## 2.0L XE Big Wing Sump modification

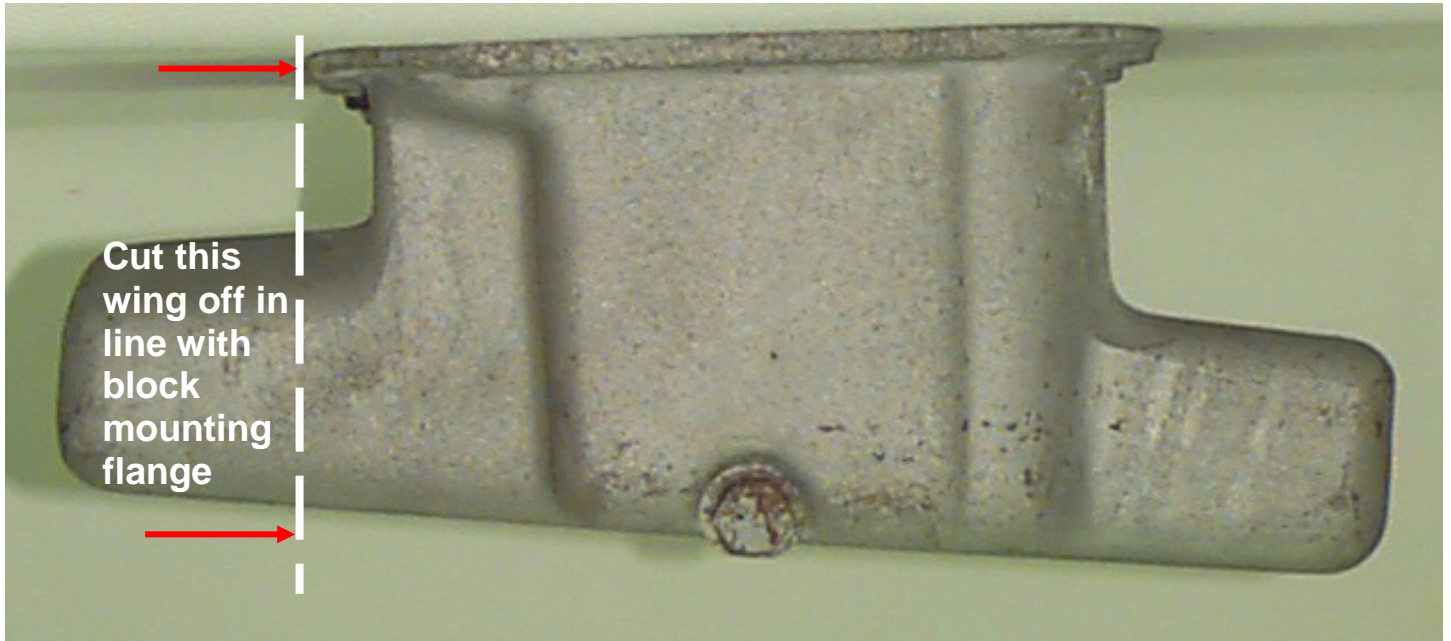
**Wing must be cut off as shown & a flat plate (at least 3/16" or 4mm thick) welded in for RWD exhaust manifold to clear sump.**
